N7554A-01

Modification Available Performance Enhancement Service Note

N7554A Electronic Calibration Module, DC- 18GHz, 2-Port

If a rework has already been done, it can easily be identified by looking at the USB connector, refer to the image below.

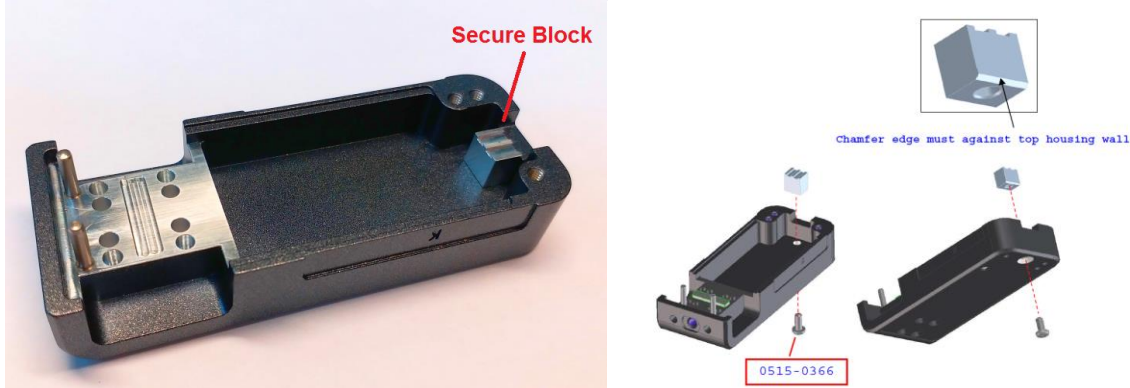
Further design review has suggested the addition of metal block on top of the housing will act as a mechanical reinforcement for the USB connector. This will help to prevent connector damage due to mishandling by user, especially when the connector gets forced up and down during plug in/out.

To add a metal secure block on top housing for mechanical reinforcement.
This modification only can be done by returning the Ecal to factory.
